SERVICE BULLETIN

SB00.10

Machines/Models: TL38 Manual Outriggers

PURPOSE: Enhance performance of the Main Hydraulic Manifold Cartridge Valves.

Figure 1

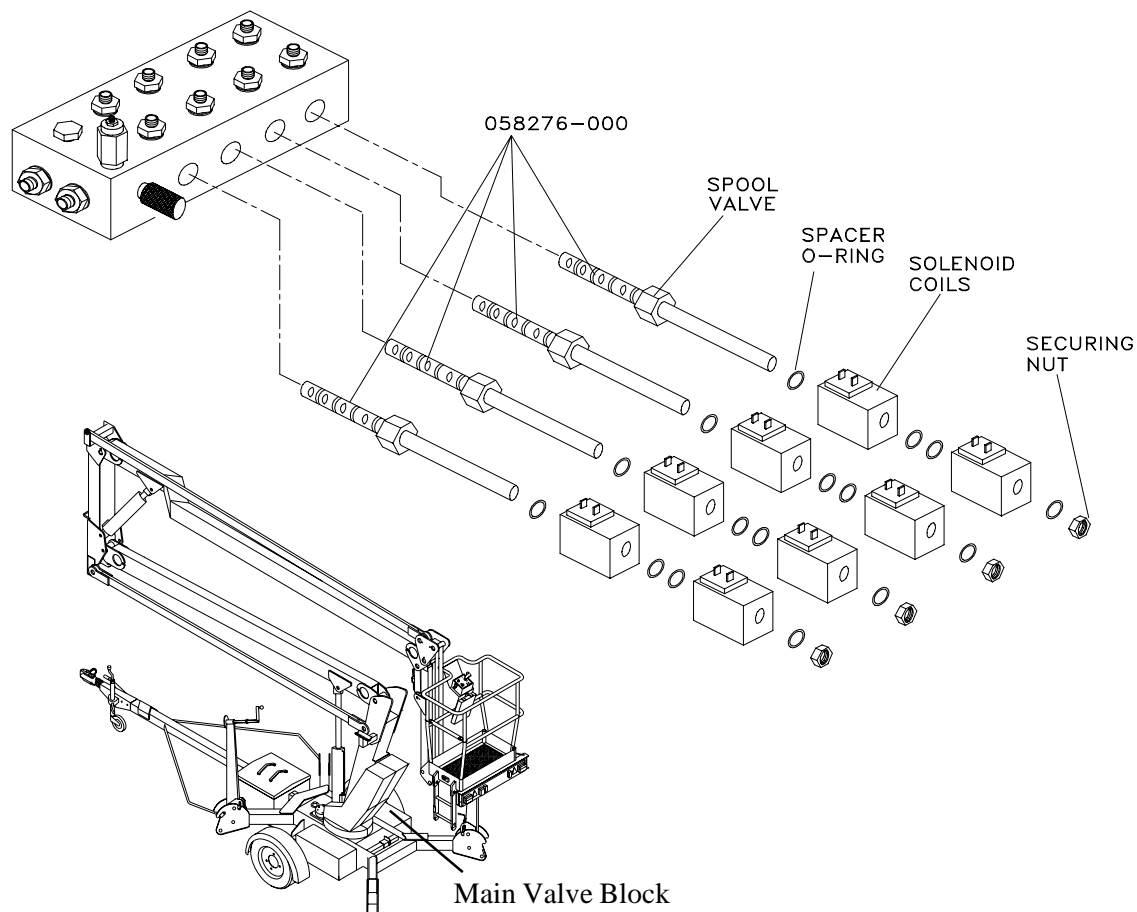
OPERATION REQUIRED: Replace the Cartridge Valves on the Main Hydraulic Manifold.

4 each - Cartridge Valve (058276-000)(S271Valve Identifier)

1. Park the machine on a firm level surface.
2. Ensure the Elevating Assembly is completely stowed and the Key Switch, upper and lower Emergency Stop Switches are in the 'OFF' position.
3. Remove the Chassis Cover and gain access to the Main Hydraulic Manifold (see Figure 1).

4. Remove the Knurled Securing Nut, the Valve Coil and Spacer O-Rings from each Cartridge Valve.
5. Remove the Cartridge Valve from the block.
6. Install the Supplied Cartridge Valve and torque to 25-30 Ft. Lbs. (34-41 Nm).
7. Install the Valve Coil, Spacer O-Rings and Knurled Securing Nut removed in step 4 and tighten finger tight.
8. Repeat the above operation for all Cartridge Valves to be changed.
9. Reinstall chassis cover and secure.
10. Perform the Pre-Operation and Safety Inspection as instructed in the Operator Manual to ensure proper operation of machine.
